CITY OF DALY CITY

**VISTA GRANDE
DRAINAGE BASIN IMPROVEMENTS PROJECT**

**ELECTRICAL BUILDING
CIVIC DESIGN REVIEW PHASE II and III**

JUNE 2019

NORTH ELEVATION

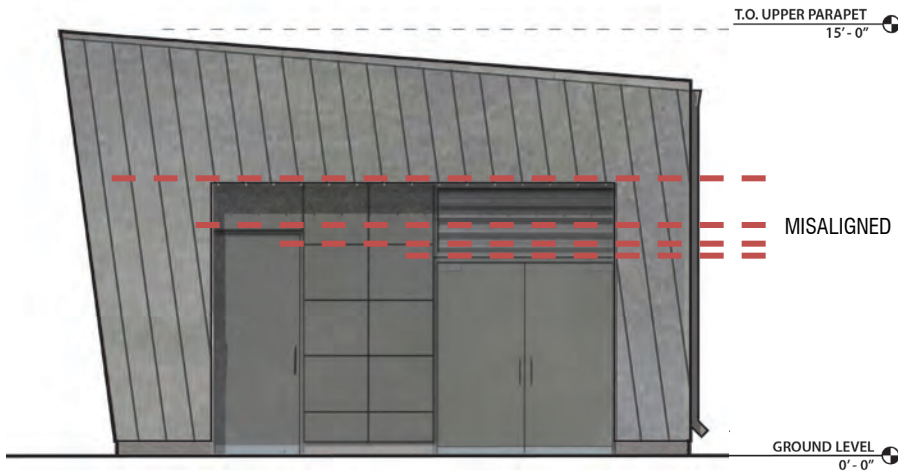
“The Committee asked that the design team give more attention to the entry way with the two doors. They shared that at this particular point everything comes together in misalignment. The Committee suggested aligning the horizontal parts above the door and minimizing the seams.”

“The Committee suggested aligning the horizontal parts above the door and minimizing the seams. The Committee also recommended simplifying the box panel in between the doors and cantilevering one side of the building to make it a more sculptural form.”

Adjust misaligned horizontal panel seams above the doors.

Matched cladding inside the door reveal to zinc standing seam cladding on exterior and aligned door heights.

NORTH ELEVATION

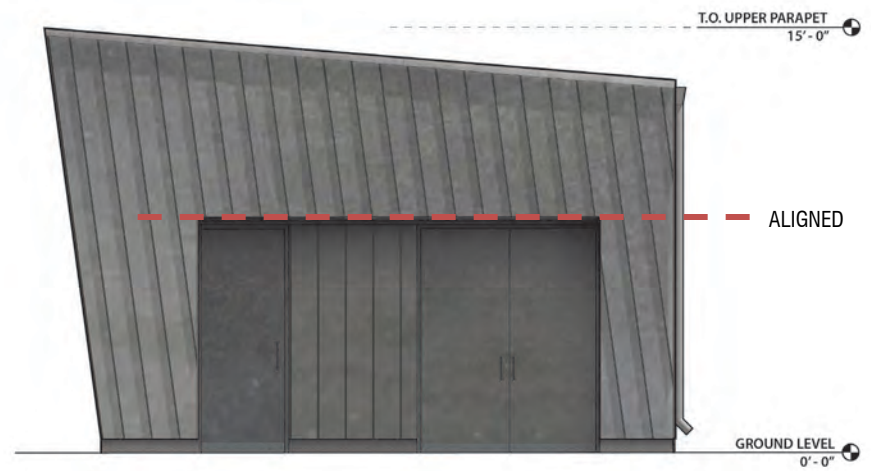
“For the landscaping, the Committee thought the plant palette was well done, but asked that taller plants be put around the fence to obscure the building more.”

Provide taller plants along John Muir Drive to obscure the building more.

Added taller plants along John Muir Drive.
